**PRELIMINARY
STAFF REPORT
2008-2009 AREA PLANS REVIEW**

SUPERVISOR DISTRICTS:Dranesville **APR ITEM:**APR#08-III-7UP; 08-III-11UP; 08-III-12UP

FIGURE 3

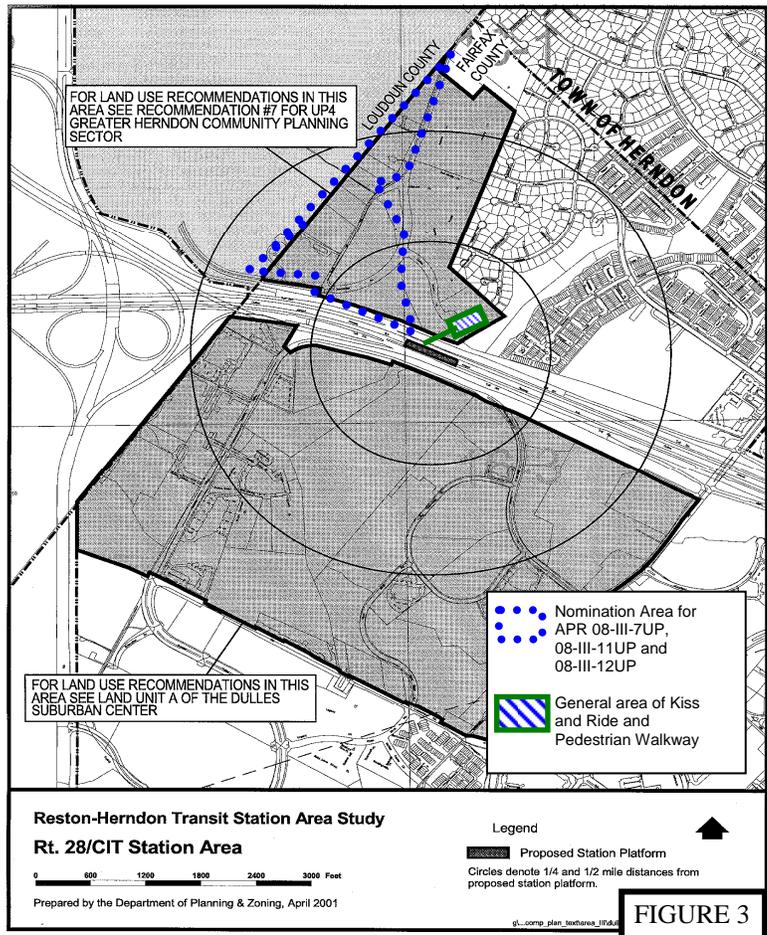
Although a large portion of the subject area is a relatively short distance to the platform, access is severely constrained by the lack of direct connection as well as the presence of a stream valley area between the subject areas and the proposed walkway to the platform, which is currently planned to be located a significant distance east of the subject areas, as shown on Figure 3.

FIGURE 5

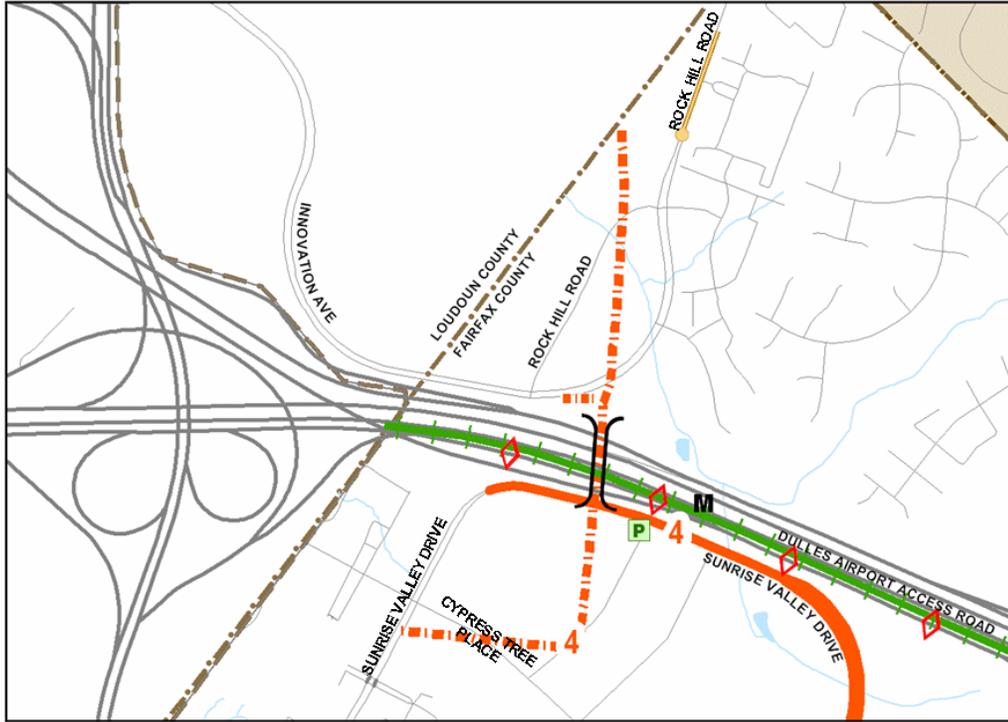
- Rock Hill Road is shown to be a 4 lane improved collector. Additionally, this road is also shown on the Map to be realigned should Davis Drive in Loudoun County be extended south. Issues to be considered include:

- A proposed cul-de-sac is shown approximately adjacent to parcel 15-2((1))1 on Rock Hill Road. Should existing Rock Hill be realigned as shown on the Map, then the proposed cul-de-sac would be implemented.

- If Rock Hill Road is realigned, it could conflict with potential development proposed in the APR nomination 08-III-12UP.
 - The Loudoun County Transportation Plan Map does not show Rock Hill Road being realigned with the extension of Davis Drive. This is possibly due to the existing rock quarry as well as other factors. However, Loudoun County's Transportation Map is currently being reevaluated. If the realignment of this road is shown on the Loudoun County Transportation Plan Map, then the potential realignment should still be accommodated on the affected parcels.

- Regardless of Rock Hill Road being realigned, existing Rock Hill Road north of Biltmore Drive and Innovation Avenue should be improved prior to any development. The road in its current condition cannot support any additional development; especially the magnitude being proposed by the three APR nominations and the Dulles World Center site in Loudoun County.

- The proposed Route 28 Metrorail Station is shown slightly to the southeast of these proposed Plan Amendments in the median of the Dulles Toll Road. As mentioned in the

- An overpass (bridge) is shown directly to the south of the nominations traversing Dulles Toll Road.
 - Currently no funding (local, state or federal) designated for the construction of the bridge.

- The construction of the bridge presents serious engineering obstacles due to the construction of the Route 28 Metrorail Station which include the location of the bridge piers, tie down into existing streets and the fact that the height of the bridge would need to clear existing ramps and/or the Metro Station.

- Options are still being explored for the location of the bridge, assuming it is feasible to construct. Without construction of the bridge there are only two entry and exit points for vehicular traffic coming to and from the subject properties. They are the Route 28 and Innovation Drive interchange and the Rock Hill Road to Sterling Road. Any traffic analysis conducted should be done with and without the planned bridge.

FIGURE 6

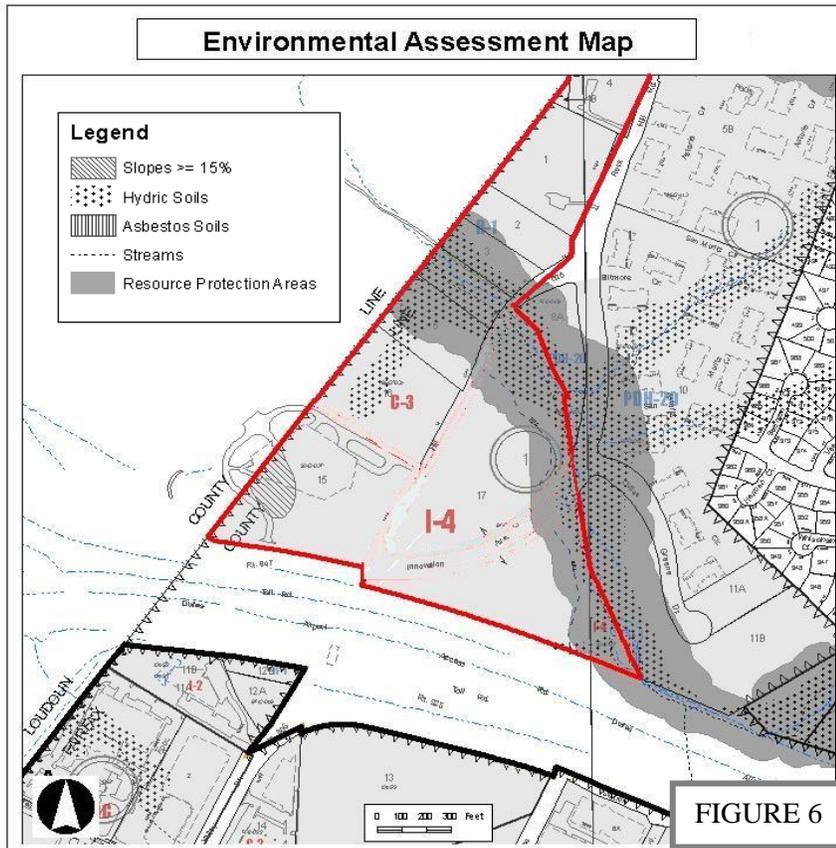
The nomination areas are located in the Horsepen Creek Watershed and a significant portion of the 08-III-11UP and 08-III-12UP nomination areas include Resource Protection Area (RPA), which is protected under the Chesapeake Bay Preservation Act. The RPA accounts for approximately 12.5 acres of the subject parcels. There are also associated areas designated as Environmental Quality Corridor and floodplain. Outside of the RPA, particularly on the 08-III-7UP property, there appears to be almost one acre of hydric soils which indicate the possible presence of wetlands. RPA and hydric soils are shown in Figure 6, the Environmental Assessment Map.
